S106 Part 1 'Application to connect to a public sewer' Approval Notice

SC5548

Land between Wood cutters Way and Castle House, Chapel en le Frith, SK23 9TQ

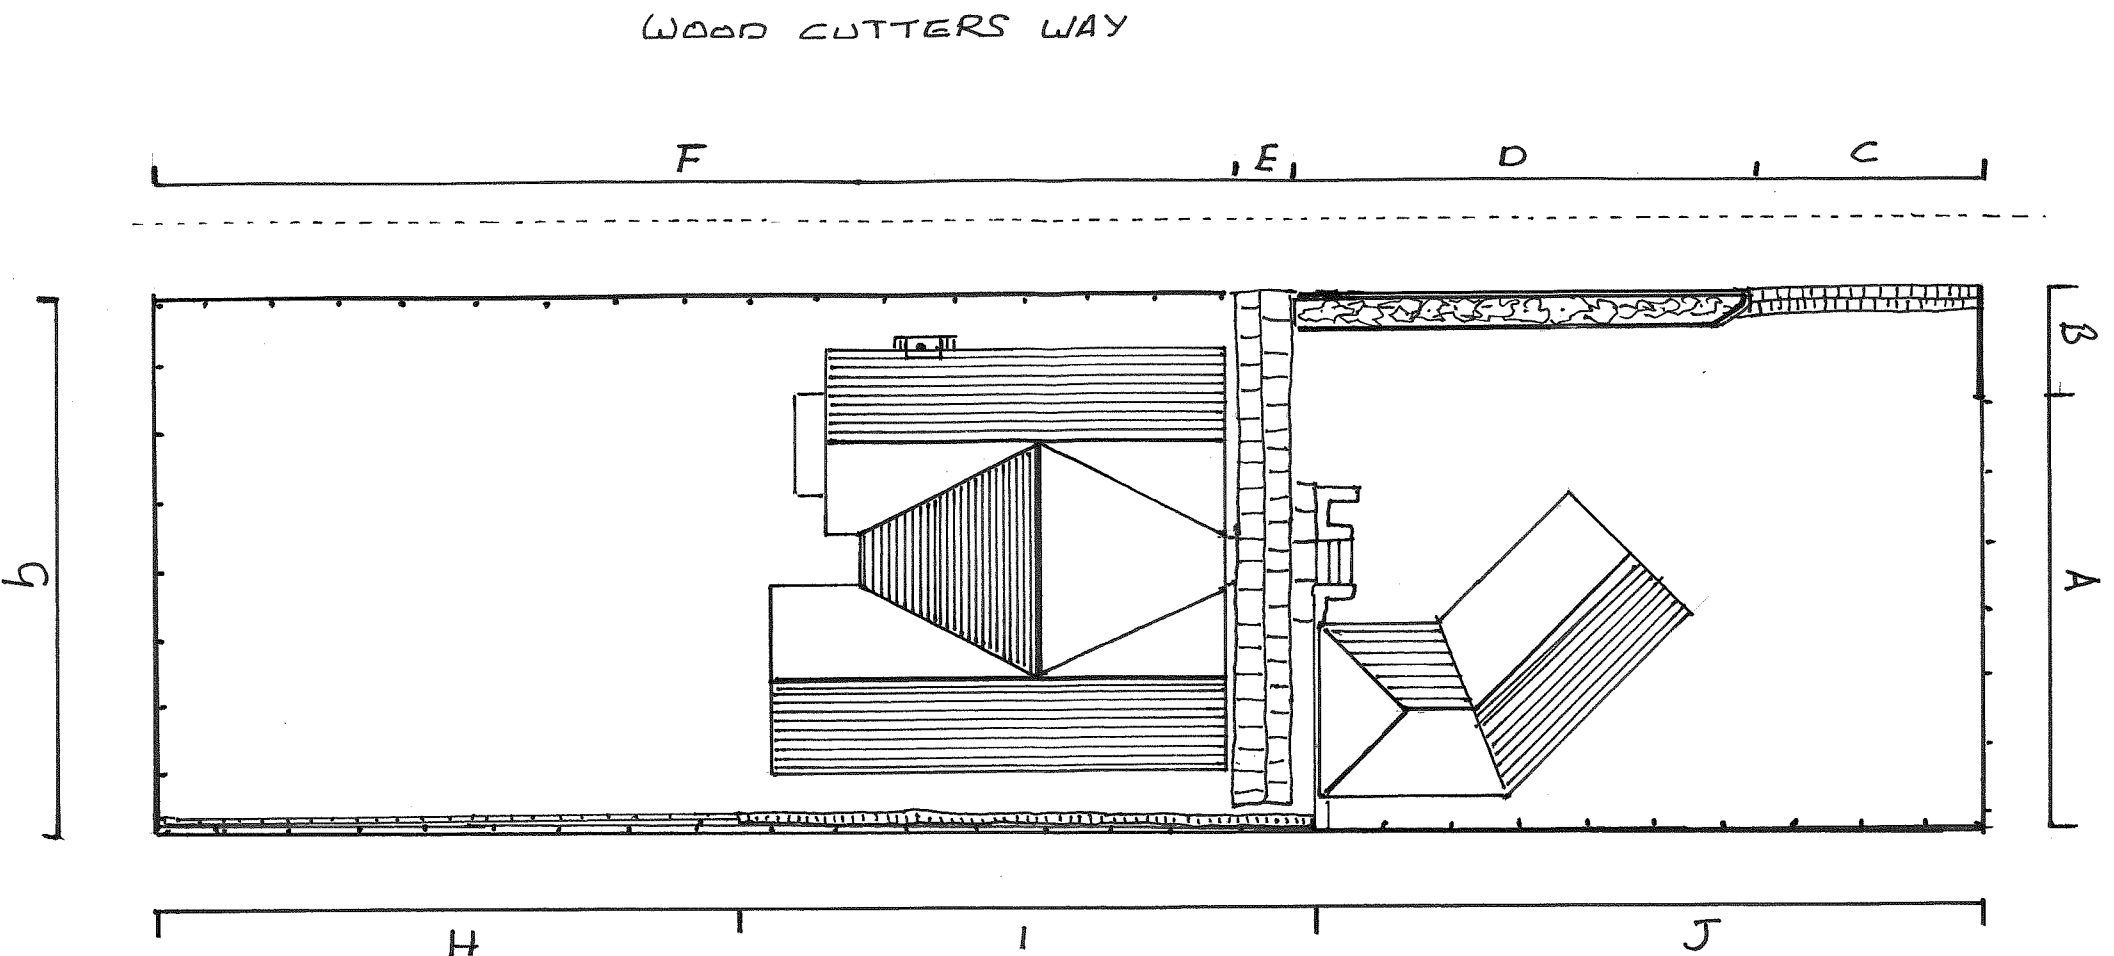
Approval for the 100mm foul only connection to the existing 150mm foul sewer in Woodcutters Way via and existing UUMH 6102

Any connection to an existing manhole should be made soffit to soffit, with a swept bend in the direction of flow. The connection must not be made in the landing area. The exact condition, location and depth of the existing manhole and surrounding services should be established as early as possible to avoid site delays. If the existing manhole is in poor condition but otherwise the connection would be acceptable, the applicant should be aware they may have to rebuild/renew the manhole if it deteriorates as a result of your contractor working on or near it.
